PL-NF-97-005

Rev. 2

# Susquehanna SES Unit 2 Cycle 9

## CORE OPERATING LIMITS REPORT

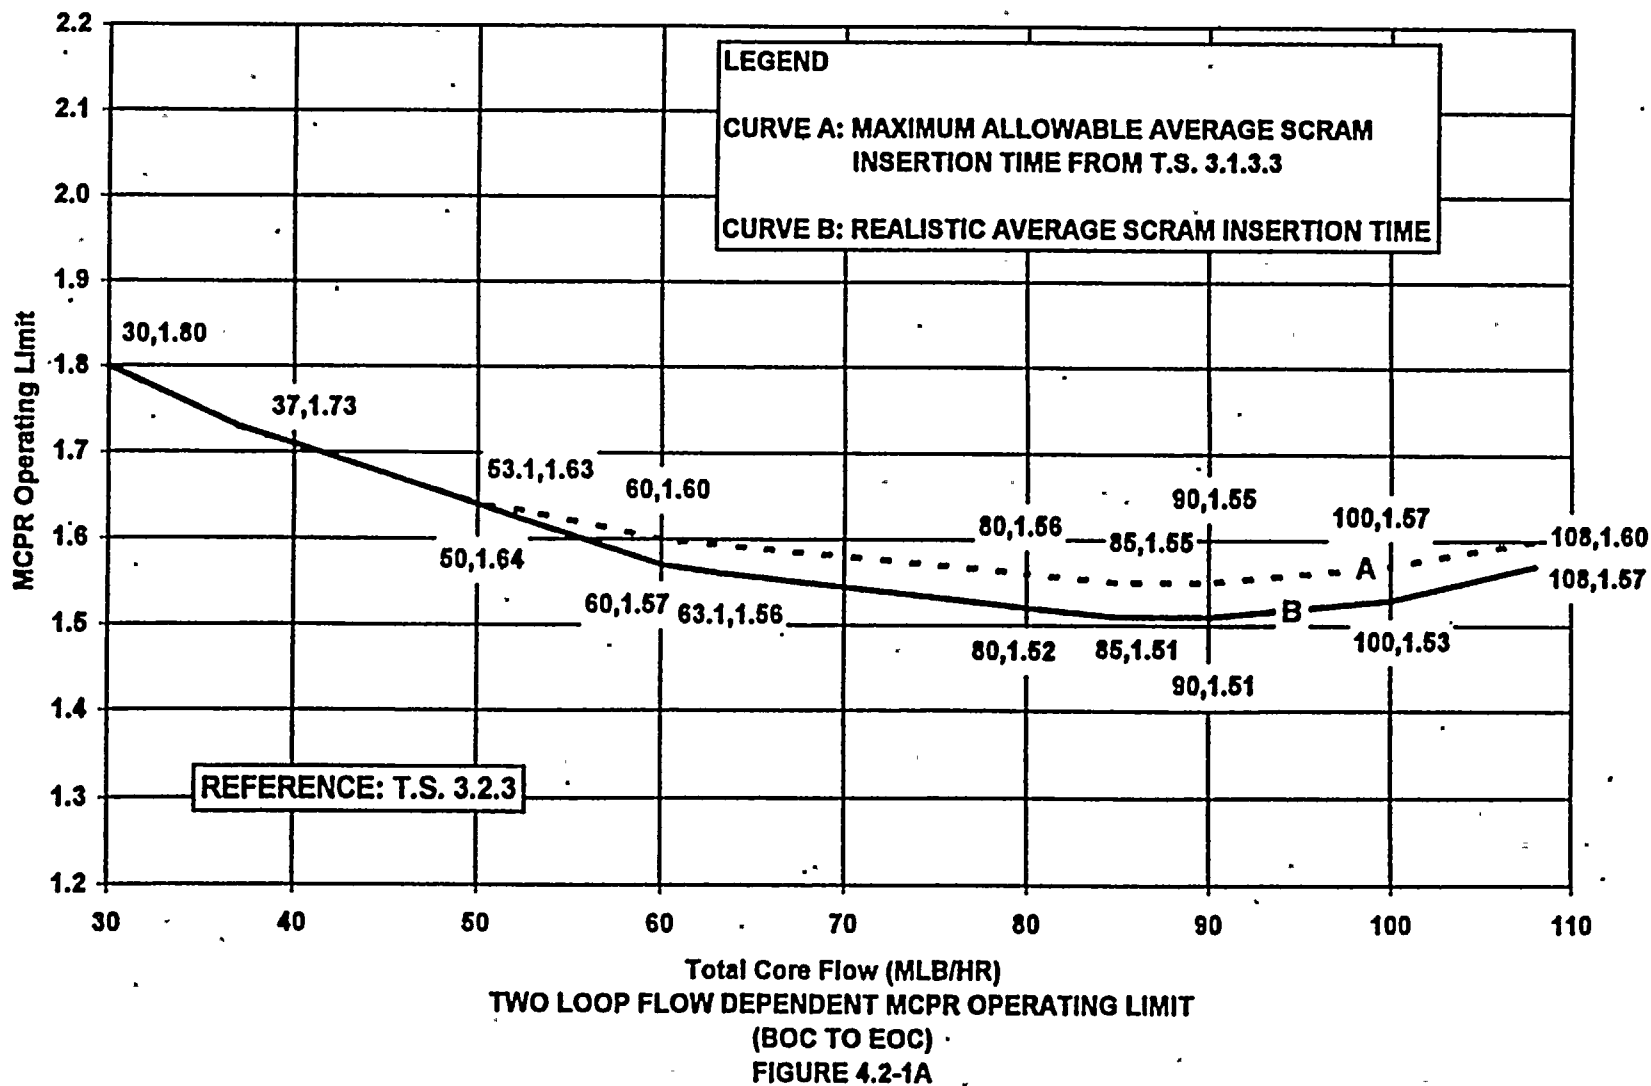
PP&L		CORE OPERATING LIMITS REPORT REVISION DESCRIPTION INDEX	
Rev. No.	Affected Sections	Description/Purpose of Revision	
2		<u>Revised MCPR Operating Limits</u>	
		The Two Loop and Single Loop flow dependent MCPR Operating Limits were revised. The revised operating limits are documented in Reference 1.	
	4.0	Revised MCPROL Figures 4.2-1A and 4.2-1B.	
	6.0	Revised MCPROL Figure 6.2-1.	
	7.0	Updated Reference 1.

Figure 4.2-1A: BOC to EOC
